UNITED STATES PATENT AND TRADEMARK OFFICE

APPLICATION NO.	FILING DATE	FIRST NAMED INVENTOR	ATTORNEY DOCKET NO.	CONFIRMATION NO.
10/797,719	03/10/2004	Toshimitsu Hirai	9319S-000729	4111

Office Action Summary	Application No. 10/797,719	Applicant(s) HIRAI ET AL.	
	Examiner TABASSOM TADAYYON ESLAMI	Art Unit 1792

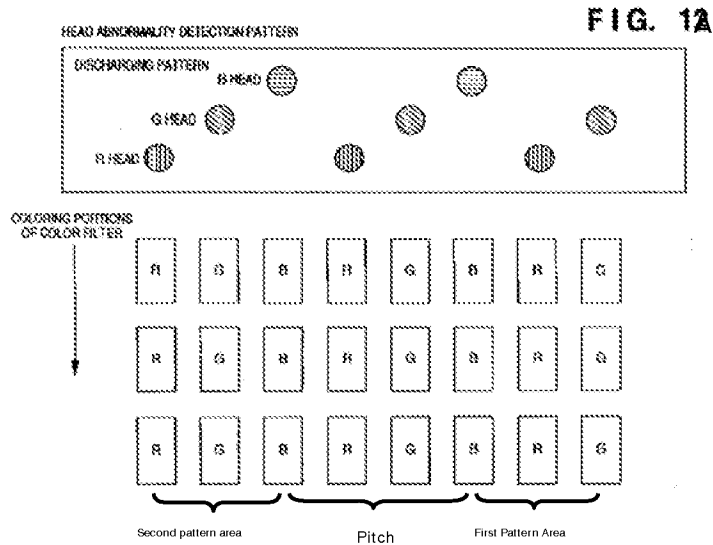
Claim 1 is rejected. 981 teaches a method of making linear film pattern by arranging droplets of a liquid discharged from a plurality of discharged portions on a substrate [fig. 12A] comprising; defining a plurality of pattern forming areas arranged with a pitch which is larger than that of the discharge portions[fig. 12A], in which the film the film pattern are to be formed on the substrate the areas including;

a first pattern forming area in which a film pattern is to be formed from a side thereof(G); and a second pattern forming area in which a film pattern is to be formed from the center thereof(G)[fig. 12A]. The droplets width is inherently smaller than the film pattern in the side of the first pattern forming area and the center of the second pattern forming area, because the width (diameter) of the droplet is smaller while it is not dropped on the surface (the volume of the droplet is consistent and when the droplet hits the center the diameter of the droplets increases as the height of the droplets on the surface decreases); and wherein the discharge portions are provided corresponding to the first and second pattern forming areas, and the droplets are arranged while moving the discharge portion in the direction in which the pattern forming area are arranged.

Claim 2 is rejected. 981 teaches the limitation of claim 1 as discussed above and it is inherent that the droplets in the first and second pattern simultaneously arranged in forming areas (G).

Claim 4 is rejected. 981 teaches the limitation of claim 1 and 981 further teaches in first pattern forming area, the side is first formed (G) and then center formed (R), and in the second pattern forming area, the center portion is first formed (G) and then the side is formed (R) [fig. 12A].

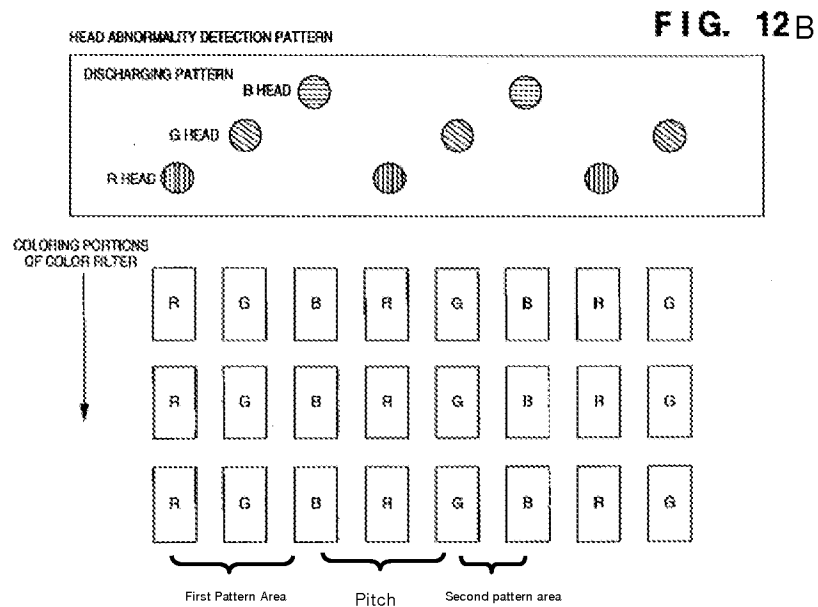
Claim 6 is rejected. 981 teaches the limitation of claim 1 and 981 further teaches; a step of forming one side of a first film pattern to be formed in the first pattern forming area (B), a step of forming a central portion of a second film pattern to be formed in the second pattern forming area at the same time as forming the other of the first film pattern (G), and a step of forming one of one side and the other side of the second film pattern at the same time as forming central portion of the first film pattern (R) [fig. 12A].

A pattern forming method of forming linear film patterns by arranging droplets of a liquid material discharging from a plurality of discharge portions on a substrate [abstract, also fig. 12B (below)], the method comprising, when a plurality of the film patterns are arranged with a pitch is larger which is larger than of the discharge portions and formed on the substrate [fig. 12B]: a first step of a first pattern forming area in which a film pattern is to be formed from a side thereof; and a second pattern forming area in which a film pattern is to be formed from the center thereof [fig. 12B]. Forming a first area (mark on fig. 12B) of a first film pattern of the plurality of film patterns (R); a second step of forming a first area of a second film pattern (G) at the same time as forming a second area of the first film pattern; and a third step of forming a second area of the second film pattern (B) at the same time as forming a third area of the first film

pattern [fig. 12]. The droplets width is inherently smaller than the film pattern in the side of the first pattern forming area and the center of the second pattern forming area, because the width (diameter) of the droplet is smaller while it is not dropped on the surface (the volume of the droplet is consistent and when the droplet hits the center the diameter of the droplets increases as the height of the droplets on the surface decreases). 981 also teaches the polarity of nozzles (304 fig. 52C) ejects the ink to print specific pattern area (color) on the surface. 981 teaches the discharge portions are provided corresponding to the first and second pattern forming areas, and the droplets are arranged while moving the discharge portion in the direction in which the pattern forming area are arranged[printing the color lines along the proposed line].
